REQUEST FOR COUNCIL ACTION

Originating Department Community Development	By GPD	Approved for Agenda by:	Date: Time:	Number:
Agenda Section DEVELOPMENT BUSINESS		Item Rezone from CB(PD) to CB, Preliminary Plat, Conditional Use Permit, and Final Site Plan and Building Plans

Case 10329ABC-97

Rezone from CB(PD) to CB, Preliminary Plat, Conditional Use Permit, and Final Site Plan and Building Plans

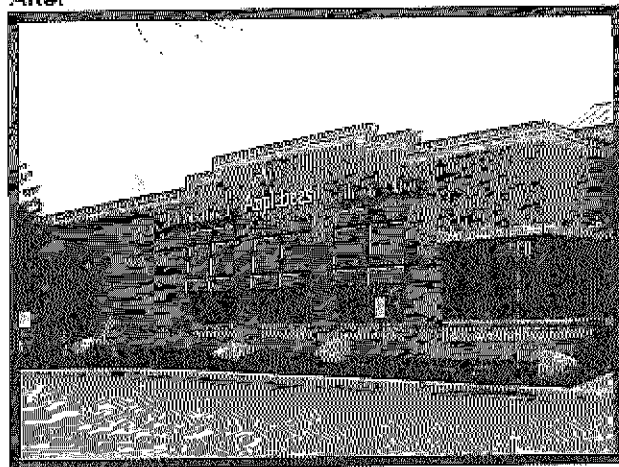
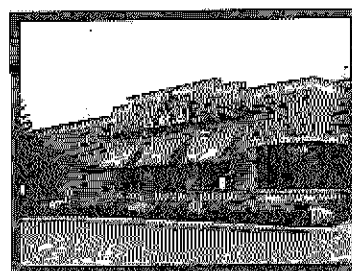
Remove existing awnings and replace with new awnings. Install new awning with the top of awning 8" below sign and bottom of awning to be 5" below top of window. Finish all sides to match TigerDrylac 3000, with a 16/0030 matte clear coat. Three inch, LED lit, frames are painted satin black.
